RE: Clarrie Hall Dam Wall Raising EIS – Assessment of Matters of National Environmental Significance (SSI-65020460)

Enclosure: Attachment 1 – Detailed DCCEEW BCS Comments – Clarrie Hall Dam Wall Raising MNES Assessment

Attachment 1: Detailed DCCEEW BCS Comments – Clarrie Hall Dam Wall Raising MNES Assessment

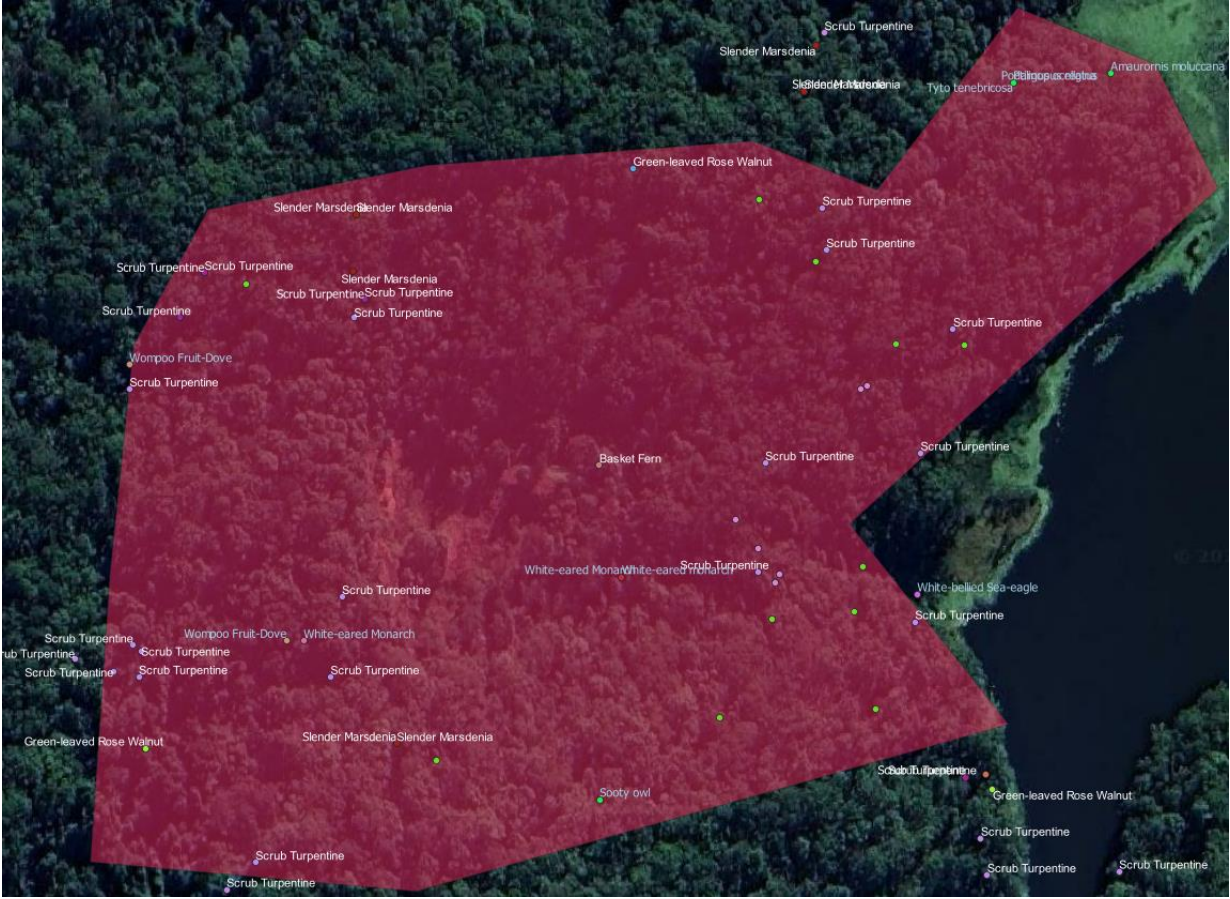
Requirement	Information	Reference (BAM / BLA ¹)
	The proposal involves re-instating a rock quarry on the subject land to source rock for construction of the project. The former rock quarry site contains known habitat for two EPBC Act listed threatened flora species, slender marsdenia (<i>Marsdenia longiloba</i>) and scrub turpentine (<i>Rhodamnia rubescens</i>) (see Figure 1 below). The BDAR has not provided any comparative analysis of alternative rock sources and their biodiversity impacts to demonstrate reinstatement of the rock quarry would have the least biodiversity impacts.  Figure 1: Threatened species records within the proposed rock quarry development footprint.

Requirement	Information	Reference (BAM / BLA ¹)
	Recommended actions: - The BDAR be revised to include a comparative analysis of potential alternative rock sources and their biodiversity impacts to justify reinstating the existing rock quarry on the subject land. - If the analysis of alternative rock sources and their biodiversity impacts concludes reinstatement of the existing rock quarry is justified, then the proponent investigate opportunities to further refine the proposed rock quarry footprint to avoid as many threatened species and their habitats as possible, particularly slender marsdenia and scrub turpentine. The EIS and BDAR identify two options for the proposed rock quarry haul road route (see Figure 2 below). Haul road option 1 would remove significantly more native vegetation and threatened species habitat and lead to greater long-term edge effects than option 2. Recommended action: - Haul road option 2 be adopted as part of the project design to minimise direct and indirect biodiversity impacts.

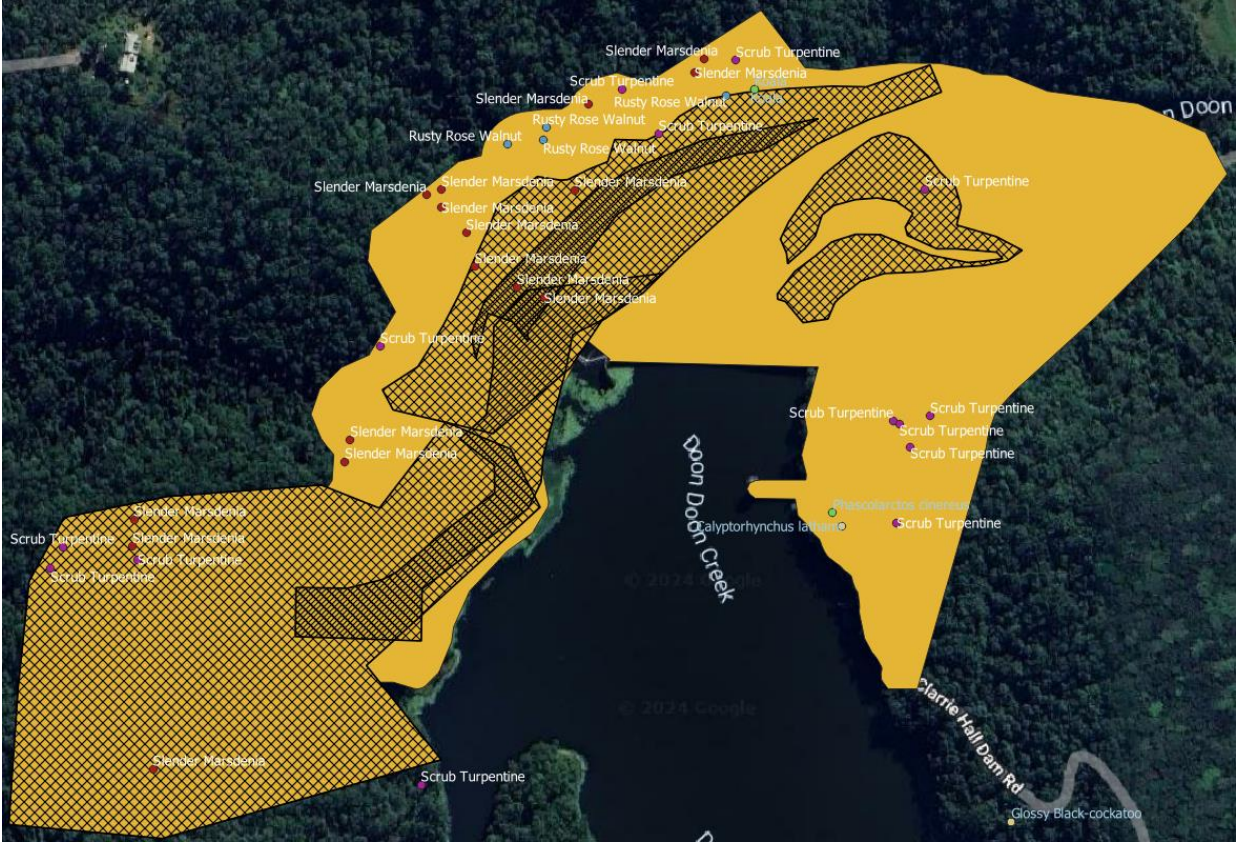
Requirement	Information	Reference (BAM / BLA ¹)
	The mapped construction disturbance area around the dam wall appears to extend well beyond the various construction components of the project, particularly if the haul road option 2 is adopted (see Figure 3 below). Biodiversity credit obligations for EPBC Act listed threatened species calculated in the BAM-C and presented in the BDAR have been based on a broader construction disturbance area, which indicates there may be opportunities for the proponent to further avoid biodiversity impacts by refining and confirming the actual development/clearing footprint.  Figure 3: The construction disturbance footprint (orange) extends well beyond the various components of the dam wall construction (cross hatched area). EPBC Act listed threatened species records are shown as various coloured dots. Note, the development footprint for the proposed realignment of Clarrie Hall Dam Road has not been provided in the BDAR.

Requirement	Information	Reference (BAM / BLA ¹)
	Recommended action: 8. The project development footprint around the rock quarry haul road, new spillway and realigned Clarrie Hall Dam Road be further refined and detailed in the BDAR to avoid biodiversity impacts. The project involves filling the dam from its current capacity of 16,000 ML to a FSL of 42,300 ML upon completion, resulting in the rapid inundation of an extensive area of threatened species habitat. The much larger FSL resulting from the project is expected to meet community water demands up to and beyond 2065. Presumably, the community water demand will increase progressively in response to population growth, hence the FSL of the upgraded dam is unlikely to be required for several decades. Section 7.2.2 of the BDAR indicates environmental stream flows in Doon Doon Creek downstream of the dam are currently supported by dam releases of 4 ML per day, which suggests the dam operator may have some control over the dam water level. Assuming the dam water level can be monitored and controlled with a reasonable level of precision via dam releases, the proponent could stage incremental increases in the dam water level in response to increasing community water demand over the next 40 years. This would significantly slow the rate of permanent inundation of threatened species habitat and provide much more time for flora and fauna assemblages to adapt and migrate in response to incremental habitat loss. It would also provide significantly more time for proposed mitigation measures involving seed collection and assisted establishment of threatened flora species beyond the future FSL. The retirement of biodiversity credit obligations generated by the project could also be further staged to align with each incremental increase in the dam water level. Recommended action: 9. Dam water levels be increased incrementally to cater for short-term projected increases in community water demand rather than immediately filling the upgraded dam to the 42,300 ML FSL, with consideration given to staging the retirement of biodiversity credits to accord with the impacts of each incremental increase in dam water level.
